In the Environment Court**ENF 13/98**Under the **Resource Management Act 1991 ("the Act")**In the matter of **an application for enforcement orders under section 314 of the Act**Between **Waitakere City Council**

Consent Order

BORRETT PROPERTY
AT 49 SUNNYVALE ROAD, SWANSON

REVIEW OF CONSENT ORDER

Fig 4 – General Areas subject to restoration agreement in 2003

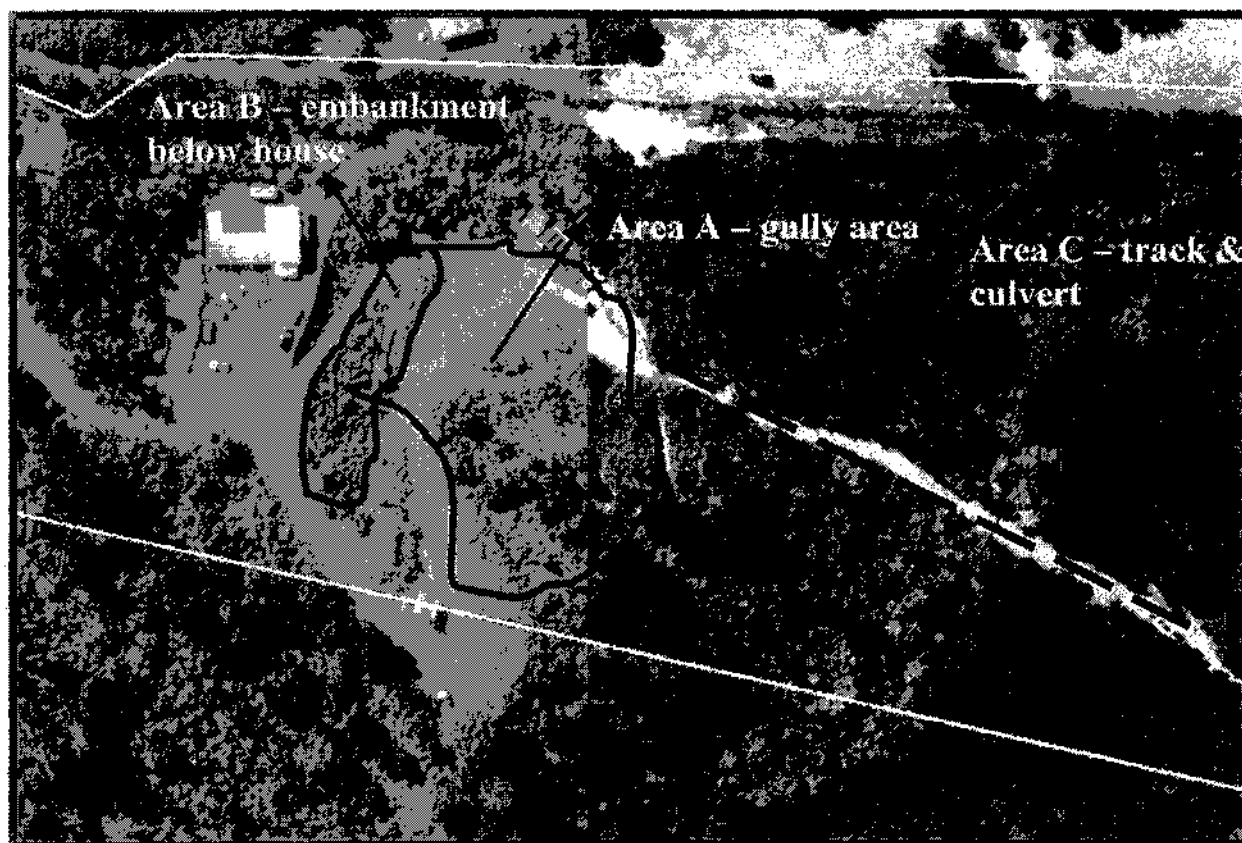
From the observations made as part of the site visit on June 21, it is evident that no or minimal weed control or planting has been undertaken in fulfilment of the restoration/replanting plan.

- the 2003 recommendations for replanting/restoration are still desirable and should be implemented
- the 2003 recommendations could be subject to some minor changes as discussed above (the suggested changes are as a direct result of the passage of time and the fact that no significant attempts have been made to either control weeds or undertake planting on the property in the last five years)

- adequate and ongoing monitoring needs to be undertaken for a period of at least 2-3 years following planting and weed control. Dead plants should be removed and replaced, and weeds continually controlled
